Access Compliance Report

Public Rights-of-Way

Intersection ID: 30441	Main Street: ELM_BEND_DR	Cross Street: CADENCE_CT	Location:	N
ADA ID: 6F3353495D1D	Ramp Type: PerpDiag	Initial Pass/Fail: Fail	Overall Compliance: No	Severity Score: 10

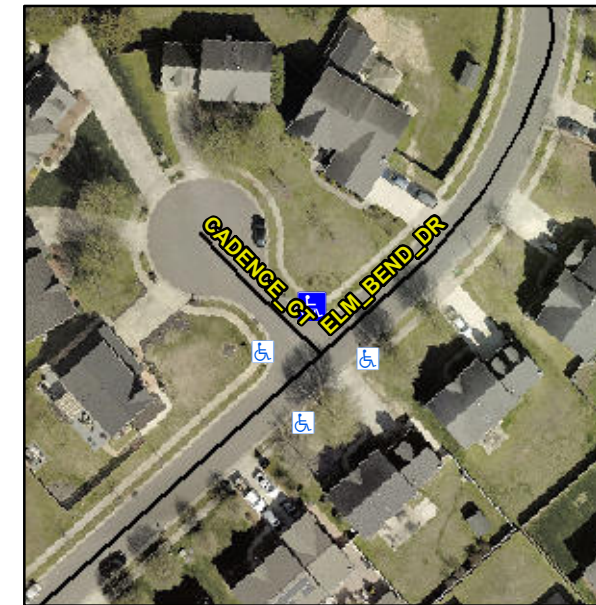
R304.5.1, R304.5.3

Compliance	Description	Data	Compliance	Description	Data
N/A	Ramp Length (in)	46.0	Yes	Ramp Slope (%)	6.2
No	Ramp Width (in)	47.0	No	Ramp XSlope (%)	2.7
N/A	Flare Type LT	N/A	N/A	Flare Type RT	N/A
N/A	Flare Slope LT (%)	N/A	N/A	Flare Slope RT (%)	N/A
N/A	Flare Traversable LT?	N/A	N/A	Flare Traversable RT?	N/A
N/A	Landing Length (in)	N/A	N/A	DWS Provided?	N/A
N/A	Landing Width (in)	N/A	N/A	DWS Contrast?	N/A
N/A	Landing Slope (%)	N/A	N/A	DWS Length (in)	N/A
N/A	Landing X Slope (%)	N/A	N/A	DWS Full Width?	N/A
N/A	Landing Curb? (Y/N)	N/A	N/A	DWS Offset (in)	N/A
N/A	Shared Landing?	N/A			
N/A	Gutter Ponding?	N/A	N/A	Gutter Slope (%)	N/A
N/A	Gutter Lip Ht (in)	N/A	N/A	Gutter X Slope (%)	N/A
N/A	Painted X Walk1?	No	N/A	Painted X Walk2?	No
	X Walk 1 Direction	To SW		X Walk 2 Direction	To SE
N/A	X Walk 1 Width (in)	N/A	N/A	X Walk 2 Width (in)	N/A
	X Walk 1 Slope (%)	1.8		X Walk 2 Slope (%)	0.4
	X Walk 1 X Slope (%)	1.0		X Walk 2 X Slope (%)	1.1

Remove & Replace Curb Ramp With Two New Directional Ramps or Equivalent.
